Date Issued :	July 14, 2022	PCN Number :	512307
Reason for Change :	Packaging Method/Quantity Changing		
Description of Change :	This notification is to inform you the part(s) listed in this notice will undergo changes for a new Delivery Unit. No changes will be made to the product as a result of this change. Samples will not be made available as this is only a Delivery Unit change.		
Reason for Short Notice :	Corrective Actions		
Assessment of Change :	Drop Test No change to parts - Form/Fit/Function		
Planned Implementation Date :	August 30, 2022		
Sample Availability Date:	July 07, 2022		
Internal Molex Qualification Date :	July 29, 2022		
Last date to request Samples by Customer :	July 14, 2022

Current Packaging

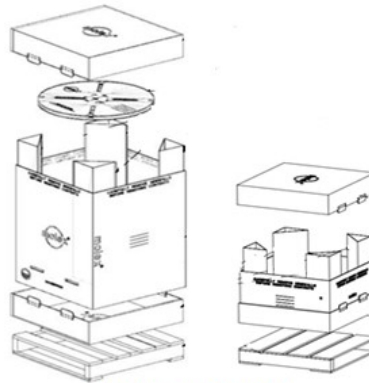
Currently there are Multiple packaging options(Reel boxes or cylinders) allowing for various quantities.
This packaging ranges from single box quantities to multiple reel quantities is cylinders.

Reel Boxes at various sizes allowing different amounts of reel to be packaged.

New Packaging

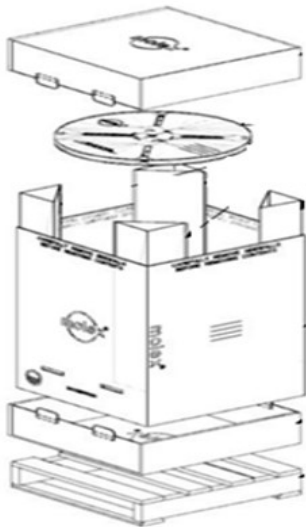
PCN will provide a common packaging type to a full cylinder and Delivery Unit quantity for the 46012 series terminal part numbers affected by this change. The current PK-46012-001 has the full cylinder qty of 24 reels equaling 96,000 pcs, full cylinder will actually be 26 reel equaling 104,000 pcs.
